STAFF REPORT

HEARING DATE: 10/27/2020
TO: Mayor & City Council
FROM: Joe Dodson, Associate Planner
208-884-5533
SUBJECT: H-2020-0046
Gateway at Ten Mile

Request for annexation and zoning of approximately 41.28 acres of land from RUT in Ada County to the C-G (26.54 acres) and R-40 (14.74) zoning districts to accommodate the future construction of a mixed-use commercial and high-density residential development, by GFI – Meridian Investments III, LLC.

B. Bubble Plan (date: 6/8/2020) (NOT APPROVED)

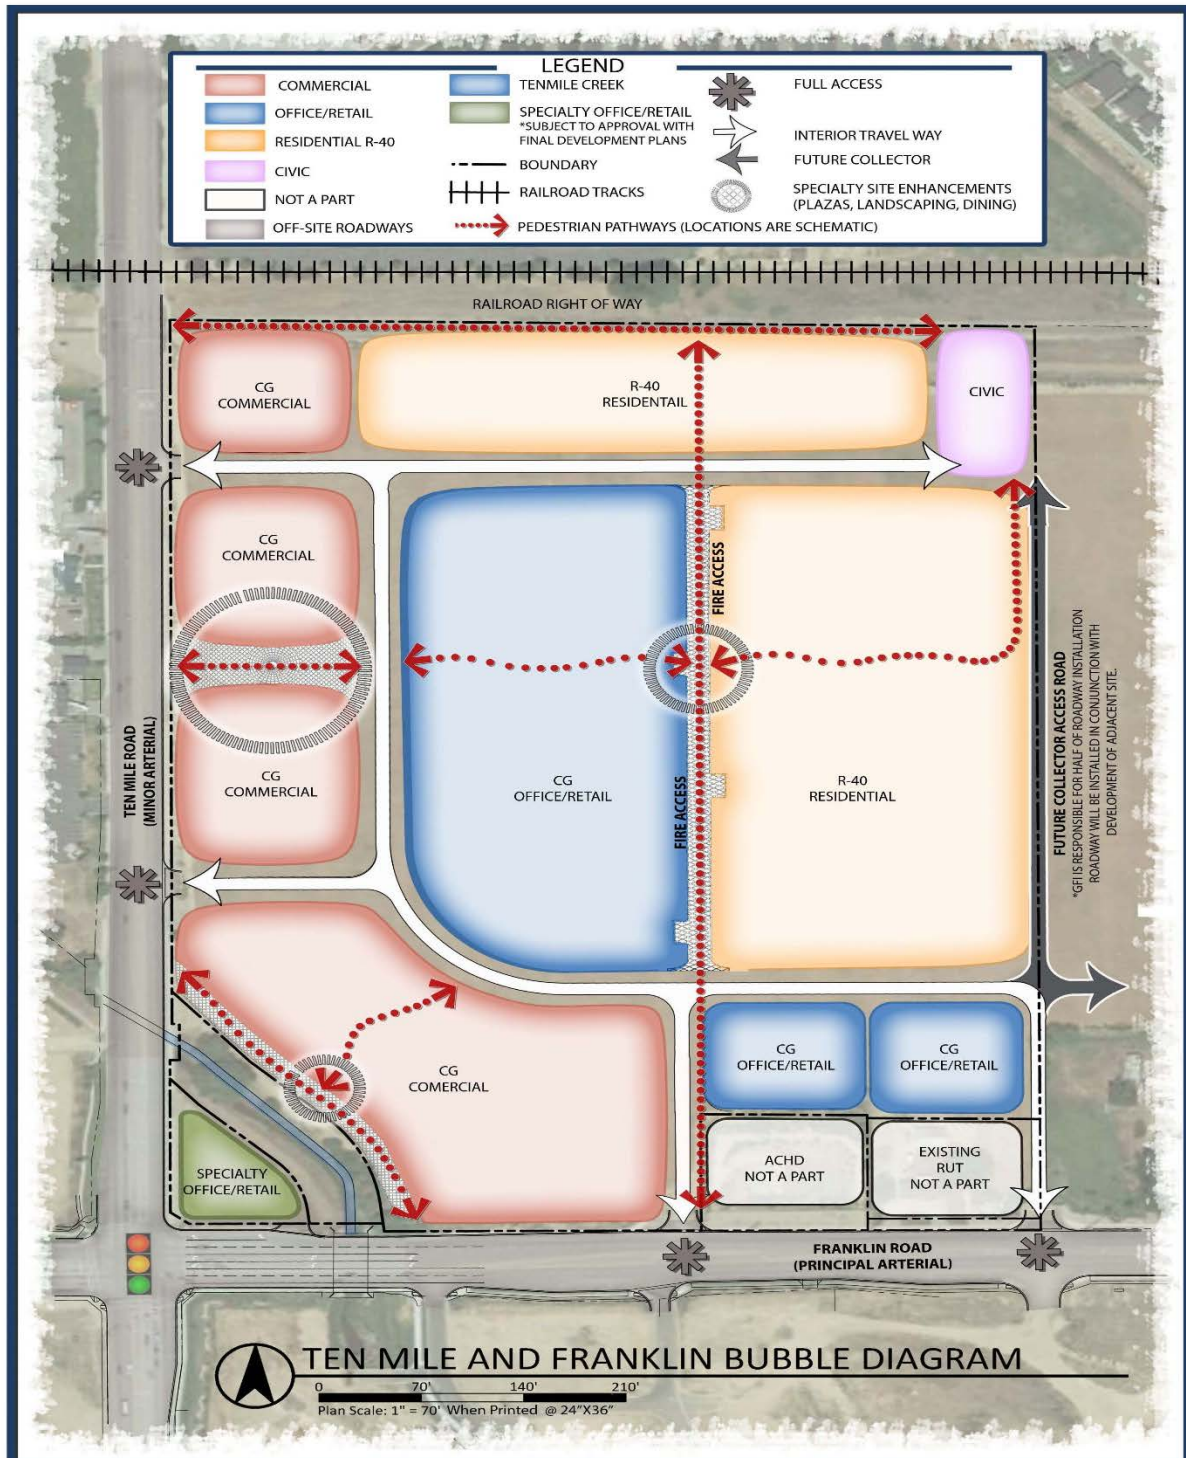
Because of these issues, Staff highly recommends that the bubble plan showing current areas labeled as office/retail and R-40 be revised to show a larger area of residential but with a combination of TN-R (Traditional Neighborhood Residential) and TN-C (Traditional Neighborhood Center District) zoning designations and provisions that at least 50% of the residential area be a combination of either Vertically Integrated structures or single-family product types. This would provide a good deal of housing choice, opportunities to transition, and the necessary guidance to ensure transit oriented and traditional neighborhood design later, with only a bubble diagram. Vertically integrated and multi-family uses are principally permitted within the traditional neighborhood districts and much of the same commercial/retail/office uses are also principally permitted. Therefore, making these changes should prove less restrictive than the proposed R-40 zoning designation.

Even though the subject site is used for agricultural purposes and has historically been so, there are multiple curb cuts along W. Franklin Road and N. Ten Mile Road, arterial roadways. The submitted bubble plan shows the Applicant's desire to keep a majority of the existing curb cuts for future access.

- a. ~~The submitted bubble plan in Section VII.B is not approved as shown. At least ten (10) days prior to the City Council hearing, the Applicant shall submit a revised bubble plan reflecting Staff's recommended revisions herein.~~

C. Revised Concept Development Plan (August September 2020)

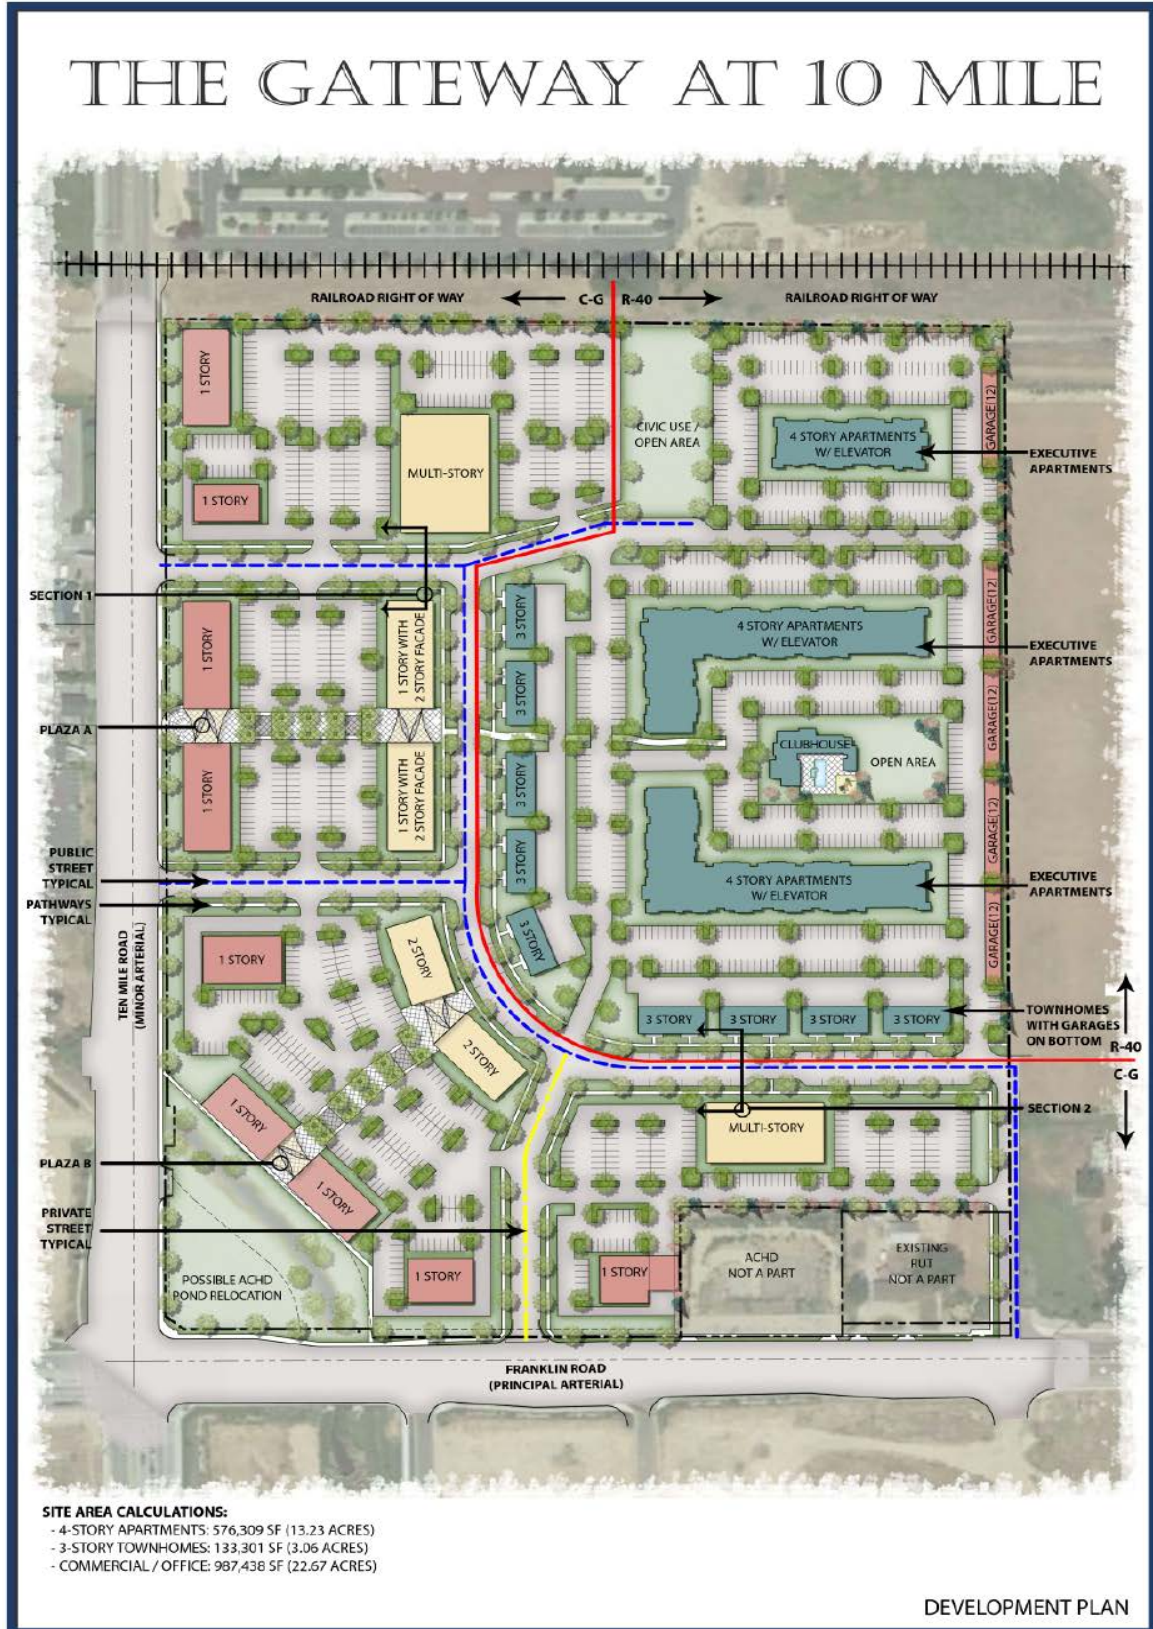
In addition, the very southwest corner of the site is constrained by the Ten Mile Creek and will severely limit any use in this section of the site. The ~~bubble~~ revised concept plan has a note stating “possible AHD pond relocation” in this area of the site. There is no guarantee that ACHD will agree to relocating their pond and the Applicant should be open to a number of possible options on this constrained piece of the property. shows a pedestrian connection to this area and no vehicular connection. This corner of the property is approximately 1.5 acres (including the easement area) and is highly visible from public roadways. This area should be treated with great care and consideration of its intended use. ~~Staff can envision the pedestrian connection shown on the bubble plan leading to a nice integrated plaza for the commercial development on the east side of the Ten Mile Creek.~~ The Ten Mile Creek should be integrated with the future uses proposed in this area similar to the design concepts implemented with the approval of the TM Creek project to the south. Staff also recommends the Applicant work with the appropriate agencies and City departments to find the best use for this corner. There could be an opportunity to provide a public use on this side of the creek.

- Incorporate plazas between compatible uses to provide shared outdoor seating and enhance pedestrian circulation between uses – The revised ~~bubble~~ concept plan shows plazas between proposed commercial uses and a shared vista between the proposed office/retail area and the high-density residential. This revised layout shows better pedestrian connection between uses and should greatly help activate the commercial uses. ~~Again, annexing in this property with the traditional neighborhood zoning designations instead of R-40 would greatly help in achieving this goal because of its pedestrian-oriented design requirements in the Plan and the UDC.~~ Some flexibility in the location of these should be assumed in the future, to ensure maximum benefit from a variety and mix of uses and various intensities and scale.

Directly to the east of this site is I-L zoning and a new Fed-Ex distribution center is nearing construction. Even though the MSM and TMISAP show the future collector roadway going further north along the shared property boundary and then heading east, Fed-Ex was not required to build a portion of the collector roadway going north-south on this shared property line. Instead, they were approved with an east-west collector road further south within their property that aligns with the proposed east-west roadway in the southern area shown in this application. This location of the collector roadway is clearly different than that shown within the TMISAP. This new location should still offer adequate cross access between parcels once fully developed but has also changed the type of future access to the Civic use in the northeast corner of this site where the collector roadway would connect to. Since the Fed-Ex distribution center was approved without constructing the north-south collector, ~~Staff does not have authority to require them to do so until that site redevelops. Therefore, the future north-south collector roadway shown on the MSM, it is not a feasible option to require this Applicant construct their portion at this time. submitted bubble plan in this application would need to be wholly constructed on this property and by this Applicant if it were to develop as shown. Staff is concerned that this is unlikely due to the circumstances outlined. Instead, Staff believes at least a public local street should be built along the eastern boundary of this site for future connectivity to the collector roadway in the southeast corner of this site that will connect to Franklin Road and for~~ Instead, Staff believes adequate access to any future transportation use in along the north boundary northeast corner of the site, shown as the Civic land use on the concept plan, can be obtained via an east-west public street connection to Ten Mile Road as depicted on the concept plan. A potential alternative to this would be to move the Civic use further west, still along the northern boundary but behind the commercial fronting Ten Mile, and ensure Staff believes the travel way shown in the north of the site is should be built as a full public access (at least a local street) to handle future traffic to and from a transportation hub instead of the private street shown on the concept plan.

In addition to the access points to Ten Mile and Franklin Road, there will be travel ways within the development. These areas appear to be shown on the ~~submitted bubble revised concept plan as a combination of public streets, private streets, and drive aisles, and not full public streets and their locations may change in the future as more specific development is proposed.~~ The road network will be the backbone of the connectivity for this development and is therefore incredibly important to the future development of this site. Staff would prefer the main travel way shown that starts in the southeast corner and curves up towards the northwest corner of the property be a public local street. ~~This is currently not a requirement due to no TIS being required at this time but~~ Staff believes creating a genuine public thoroughfare would help traffic flow and create a grand drive through the development lined with street trees and pedestrian walkways.

- c. ~~The Applicant shall revise the bubble plan to show a larger residential area to include those areas shown as "office/retail" and annex into the City of Meridian with TN-C (Traditional Neighborhood Center District) and TN-R (Traditional Neighborhood Zoning District) zoning instead of the requested R-40 zoning designation. At least ten (10) days prior to the City Council hearing, the applicant shall provide revised legal descriptions and exhibit maps for the requested C-G and R-40 district and the recommended TN-C and TN-R zoning districts to reflect the revised concept plan as seen in Exhibit VII.C.~~

- l. The Applicant shall construct the east-west street in the northern portion of the site as a full public street along the eastern property boundary and wholly on this property starting at the collector roadway in the southeast corner of the property and ending in the northeast corner of the site where the Civic future land use is shown on the bubble revised concept plan in Exhibit VII.C.

E. Proposed Street Sections and Plaza Exhibit

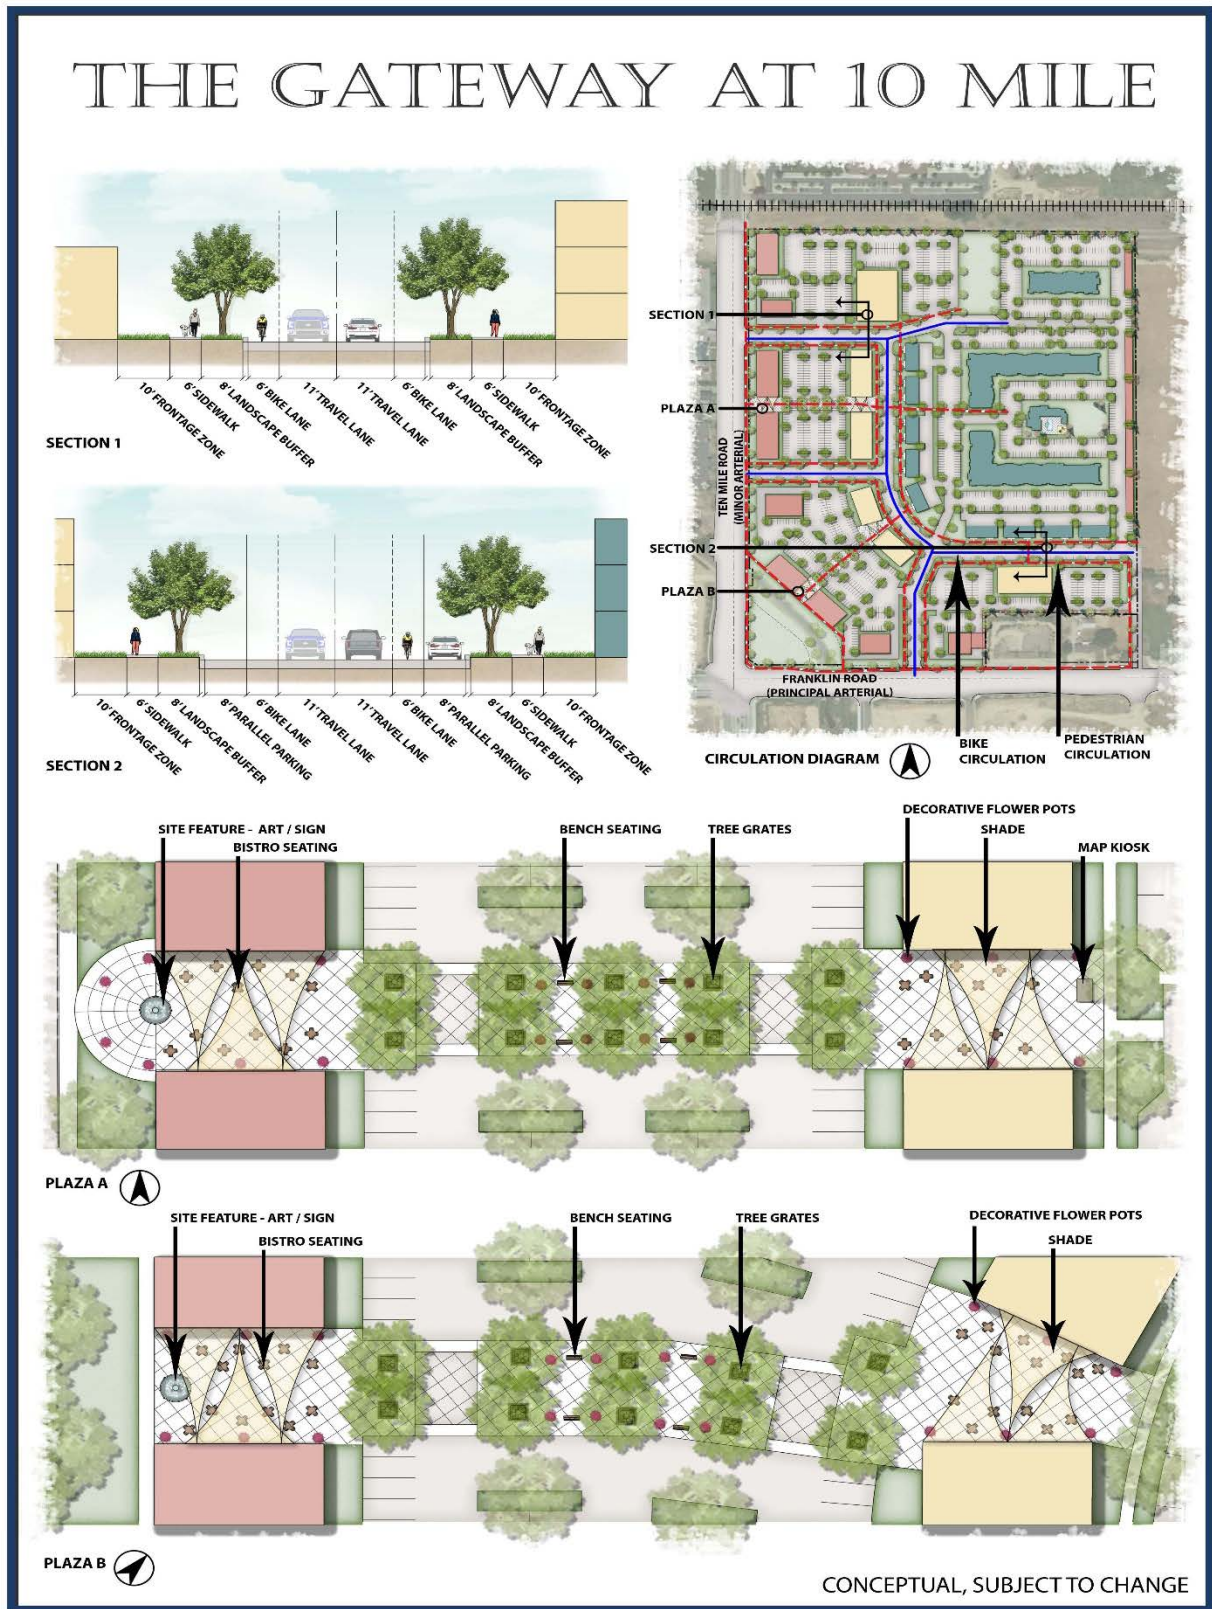
The Applicant has provided an exhibit of these plazas showing what appear to be raised crossings for vehicles (adding pedestrian safety), benches with trees within tree grates, and sails providing shade for bistro tables between the commercial buildings. Staff finds that these details within the submitted exhibit show integration of pedestrian elements and better access to the proposed commercial/retail buildings for those who will live and work on-site or nearby. Future development of these plazas should minimally contain these main elements to ensure compliance with the TMISAP and Comprehensive Plan. Staff is recommending provisions in line with these elements.

Staff is fully supportive of the proposed street sections as they mirror those presented as “Street Section C” and “Street Section D” within the transportation section of the TMISAP (see page 3-20 and 3-21 of the TMISAP). The submitted renderings include street trees, bike lanes, on-street parking, and detached sidewalks—all of these elements are desired within the Ten Mile area and especially within Mixed Use Commercial land use designations where pedestrian oriented design is expected. Whether the final street layout within this development is private or public, Staff is recommending that minimally the main streets within the development be built with these street sections in mind. Having traditional neighborhood zoning designations instead of the R-40 would also help achieve this goal, as stated throughout the staff report. The roadway shown along the eastern property boundary however, is an integral local and likely regional connection to this development and any future regional transportation hub on this site as discussed above.

- g. All street cross-sections (excluding commercial parking lot drive aisles) shall be consistent with the submitted cross-sections as shown in Exhibit VII.E, commensurate with the Ten Mile Interchange Specific Area Plan (TMISAP) for traditional neighborhood design. Commercial drive aisles should still be designed with a high degree of pedestrian connectivity and comfort in mind, and utilize on-street parking where feasible to separate pedestrians from automotive traffic.

- u. The proposed plazas as shown in Exhibit VII.E shall be built as raised islands for added pedestrian safety and placemaking; the addition of bollards shall also be considered for added safety and to delineate travel areas.
